## PRODUCT CHANGE NOTICE:

Material change for Inpac products

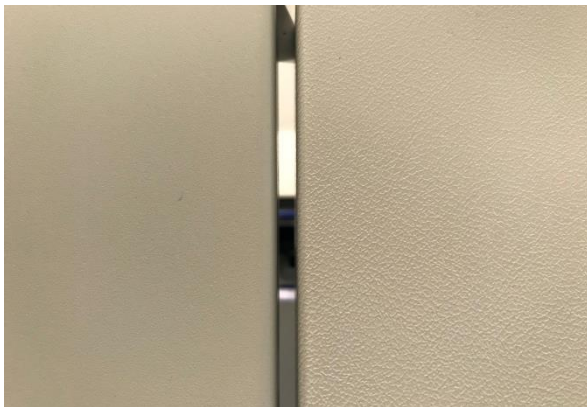
Current Material	New Material
<b>Material</b>	.88mm steel	1.0mm steel (ST-BL 1.0330)
<b>Plating</b>	Inside = Zinc plated Outside = Plastic coated	Inside and outside zinc plated (DC01-B-M DIN EN 10130/10131)
<b>Powder Coat</b>	RAL 7035, outside only	RAL 7035, inside and outside
<b>Grounding</b>	With GND / earthing connection

Technical properties are similar, but materials are different aesthetically.

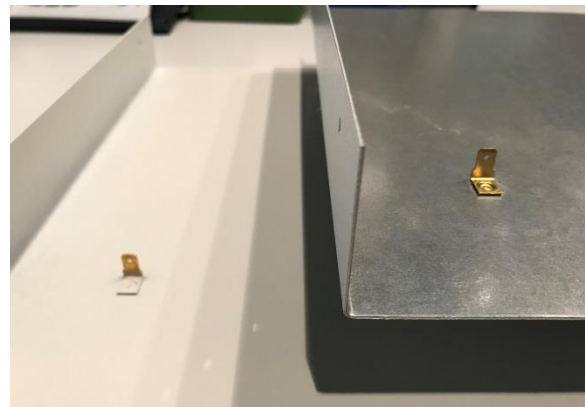
New material (left), current Material (right), The exterior surface will be the same color, RAL 7035, but with a finer texture.

New material (left), current Material (right), All surfaces of the cover, including the interior, will be powder coated.
